# **Yealink SIP IP Phones Release Note of Version 71**

T28: 2.71.0.130(Beta) upgrade to 2.71.0.140(Business)
T26: 6.71.0.130(Beta) upgrade to 6.71.0.140(Business)
T22: 7.71.0.130(Beta) upgrade to 7.71.0.140(Business)
T20: 9.71.0.130(Beta) upgrade to 9.71.0.140(Business)

• Applicable Models: SIP- T28/T26/T22/T20

• Release Date: September 24, 2013

#### 3. Added Reboot in Talking configuration in Web UI.

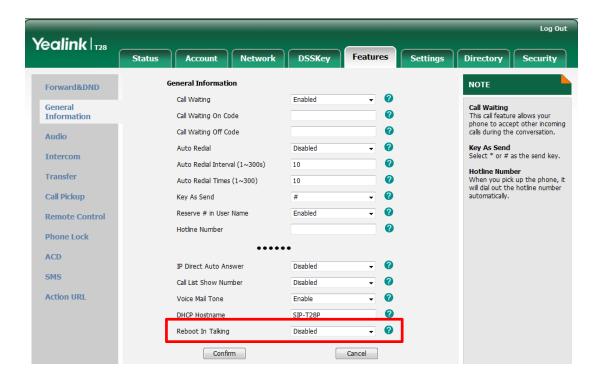
**Instruction:** Allow to forcibly reboot the phone during a call when the phone received a reboot massage by Action URI if this configuration is enabled.

**Path:** Web UI → Features → General Information → Reboot in Talking.

0- Disable (default), 1- Enable.

## 4. Added DHCP Hostname configuration in Web UI.

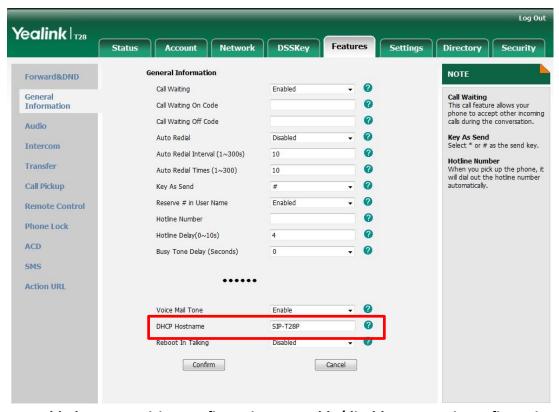
Instruction: Phone updates the Hostname to DHCP server via DHCP Option 12.

**Path:** Web UI → Features → General Information → DHCP Hostname.

#### 12. Added dynamic getting Ipv6 feature.

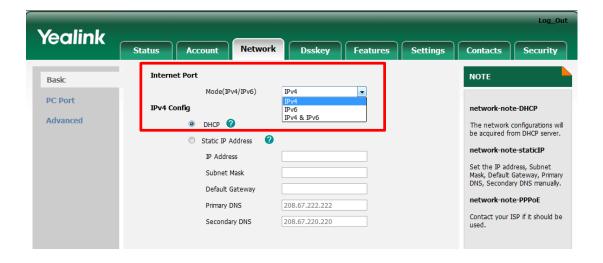
**Instruction:** Added dynamic getting Ipv6 feature, it automatically configures ICMPv6 if no status .

**Path**: Web UI → Network → Basic.

New options: Mode(IPv4/IPv6): IPv4,IPV6,IPv4&IPV6 (default setting is IPv4&IPV6)

## 13. Added dynamic getting VLAN feature.

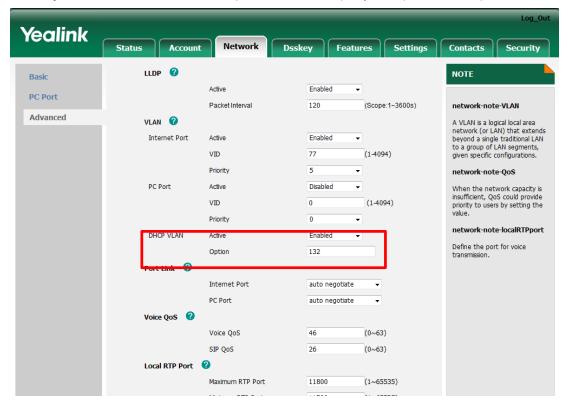
**Instruction:** In V70, the phone only support gets VLAN by LLDP and put the value of VID and Priority into VLAN parameters which were manually configurated. We added DHCP option to get VLAN in new version 71, and separate the LLDP and manually setting VLAN methords.

**Path**: Web UI→Network→Advanced.

New options: DHCP VLAN Active (default enabled), Option (default 132).

#### 14. Added SIP server backup feature.

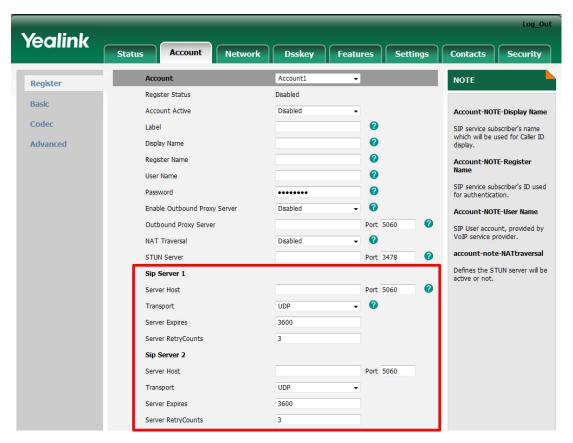
**Instruction:** Backup SIP server is actually a disaster recovery backup system, users can register two sip servers at the same time, phone use the primary sip server by default, and it will change to the second sip server if the primary sip server is down and stop working.

**Path:** Web UI→Account→Register.

#### 15. Added DNS Cache feature.

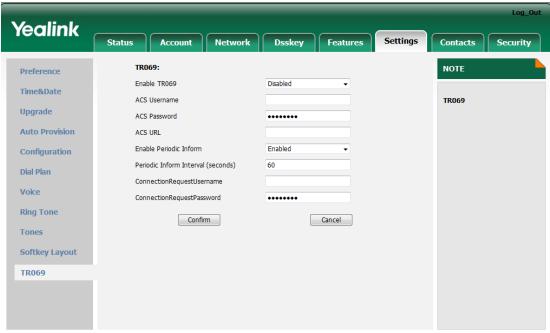
**Instruction:** DNS Cache feature is a solution for the phones which there is not DNS server configured or when the DNS queries can't get any reply. When the phone can't get a result from DNS server, users can set a value in DNS Cache themselves.

1. Optimized the type of Line in Dsskey: Deleted the Auto type and set Line 1 as default.

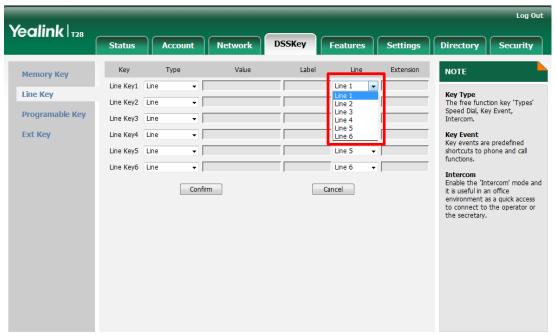
**Description:** Deleted the Auto type and set Line 1 as default on Web UI and LCD.

2. Optimized Network Directory interface: Optimized user experience in Web UI.

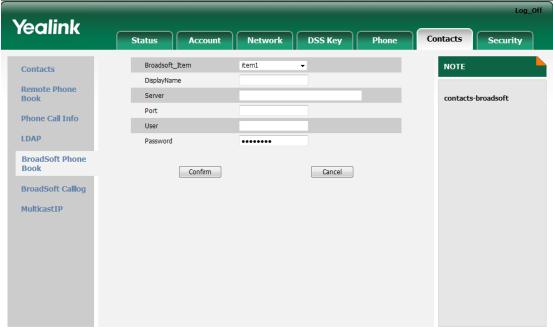
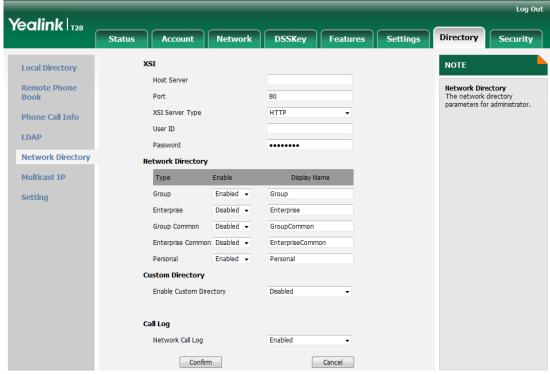
**Description:** Changed display name from Broadsoft Phone Book into Network Directly. Added more options into Network Directly interface to optimize user experience.

4. Optimized Network Directory: Added Auto Provision configuration to configure the display name of Group Common and Enterprise Common.

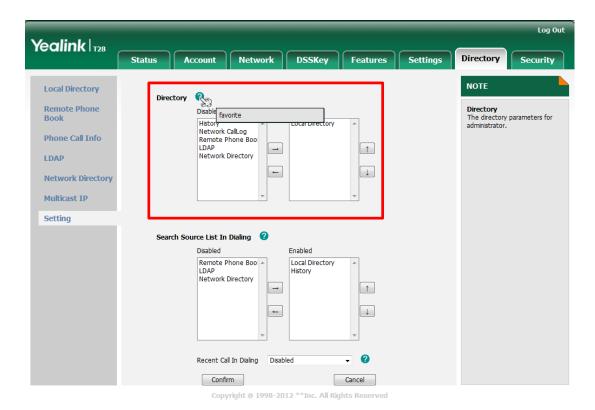
**Description:** Added Auto Provision configuration to configure the display name of Group Common and Enterprise Common.

**Path**: Web UI→Directory→Network Directory→Group Common / Enterprise Common.

#### 7. Optimized port: Added PC Port Active configuration in Web UI.

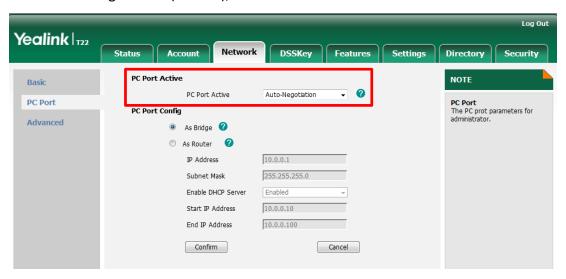
**Description:** To configure the PC Port to Auto-Negotiation or not.

**Path:** Web UI → Network → PC Port → PC Port Active → PC Port Active.

- The Auto Provision configuration: network.pc port.enable =
- 1- Auto-Negotiation (default), 0- Disable.

## 8. Optimized Interval (Minutes) configuration: Changed 60 into 1400 as default.

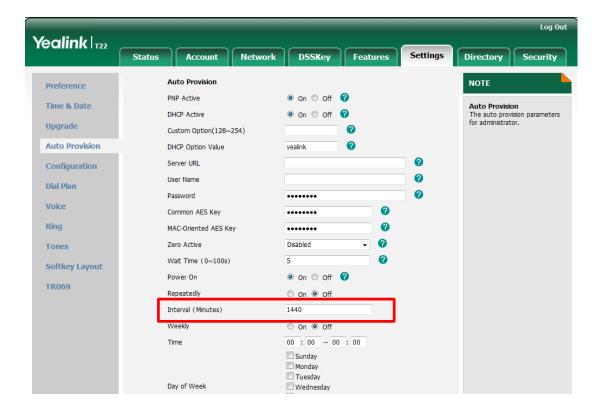
**Description:** Change the Interval time from 60 into 1400 as default.

**Path:** Web UI→Settings→Auto-Provision→Interval (Minutes).

9. Optimized certificate feature: Added 30 CA certificates and one Device certificate in factory settings.

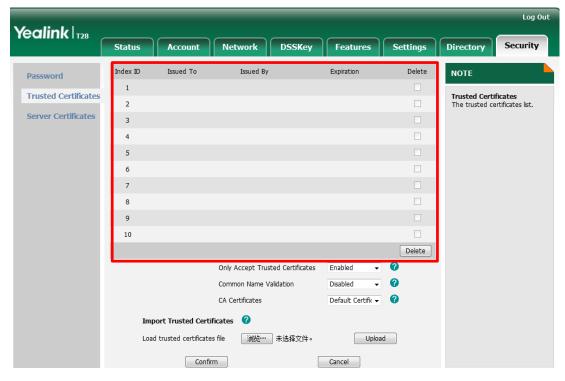
**Description:** Added 30 CA certificates and one Device certificate in factory settings. You can only see the certificates user uploads normally in this interface.

11. Optimized logo in Web UI: Added model information of phone behind the LOGO.

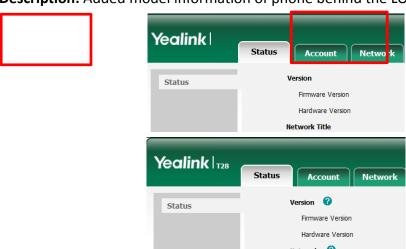
Description: Added model information of phone behind the LOGO like below.

12. Optimized keypad lock: Deleted the type of Lock& Auto Answer.

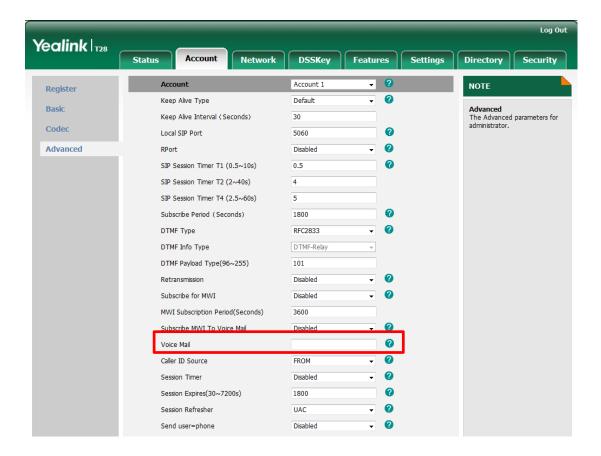
**Description:** Delete the type of Lock& Auto Answer in Web UI / LCD.

**Path:** Web UI → Features → Phone Lock → Keyboard Lock Type.

## 15. Optimized Block XML In Calling option: Optimized user experience in Web UI.

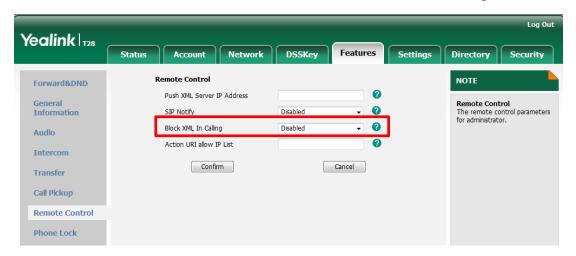
Description: Optimized user experience in Web UI.

- Move from: Web UI→General Information→Block XML In Calling.
- Move to: Web UI→Features→Remote Control→Block XML In Calling.

## 16. Optimized Tones: Deleted Record tone configuration in Web UI.

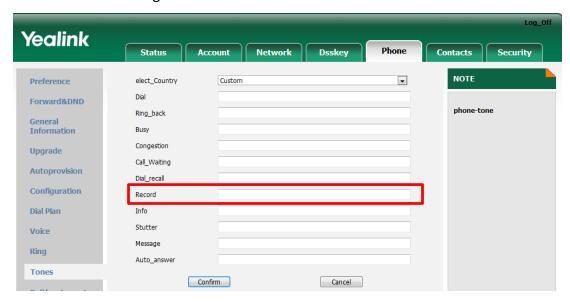
Description: Deleted Record tone configuration in Web UI.

**Path:** Web UI→Setting→tones.

## 17. Optimized Server Certificate: Added the display of Device Cert status on LCD.

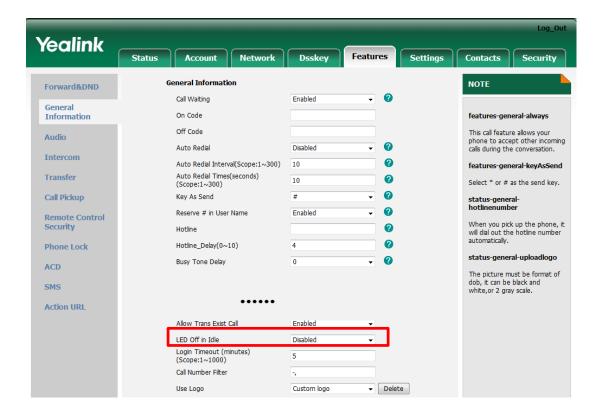
**Description:** Added the display of Device Cert status on LCD. The values of Device Cert are Factory Installed/Not Installed.

**Path:** Status → More → Phone → 6. Device Certificate.

#### 19. Optimized BLF: Deleted BLF Notify Type.

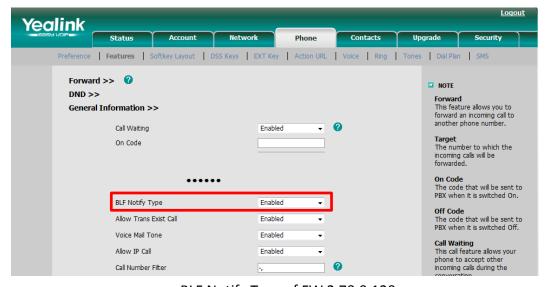
**Description:** Delete BLF Notify Type in General Information.

**Old Path:** Web UI→Phone→Features→General Information.

## 24. Optimized the search feature of directory list searching.

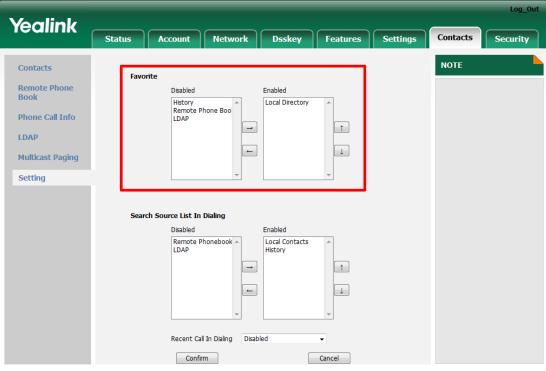
**Description:** Optimized the search feature of directory list searching in V71, it supports searching local phonebook, remote phonebook, LDAP, blacklist, and BroadSoft directory. The third softkey is configured as "SEARCH" by default. The searching source can be selected before searching. For example, if "XML remote phonebook" is selected as searching source, then it only searches from the "XML remote phonebook".

#### 26. Optimized the option of custom searching source.

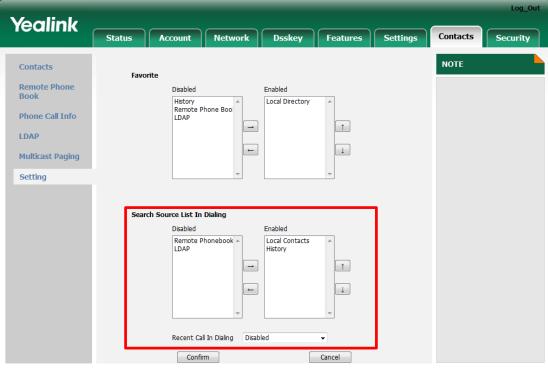
**Description:** Users can customize the items of the searching source list. the source contain Local Contacts, History, Remote Phonebook, LDAP and Network Directories.

**Path**: Web UI→Contacts→setting.

## 27. Optimized the setting of Dsskey.

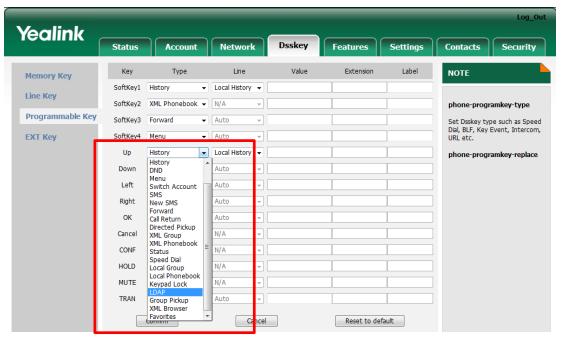
**Description:** User can long press the Memory Key or Line Key for more than 3 seconds, and it will go into setting Dsskey interface directly.

29. Optimized the web UI: The WEB UI is adjusted to unify the WEB interface with the T3x phones. Important change: The primary Phone page is replaced by the Features Page and the Upgrade page is replaced by Setting page.

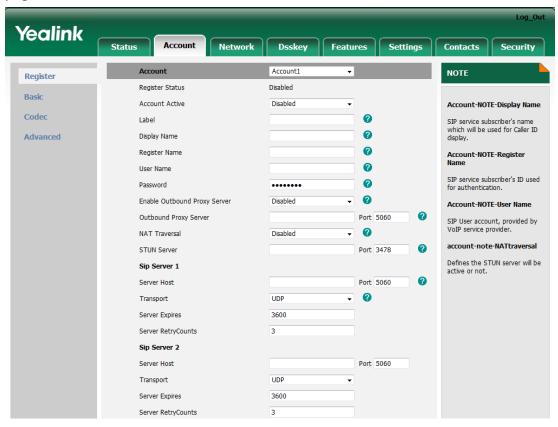
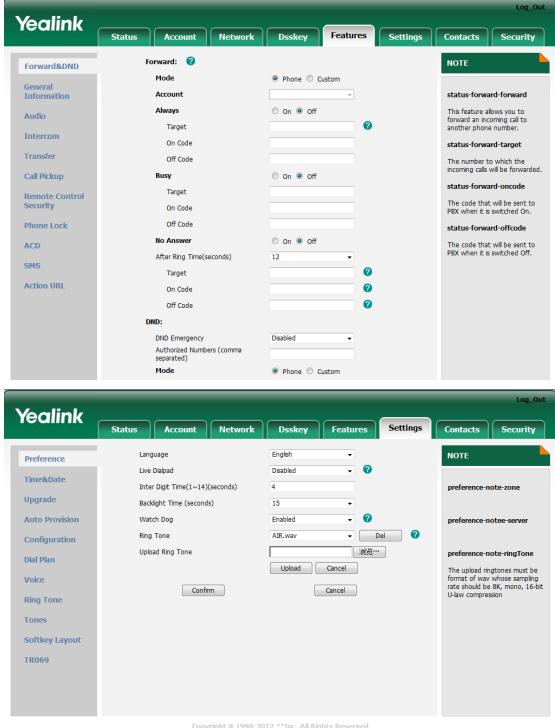
**Description:** In the Account page, divided it into two parts by Register page and Basic page:

Phone page is replaced by Features page and Settings page:
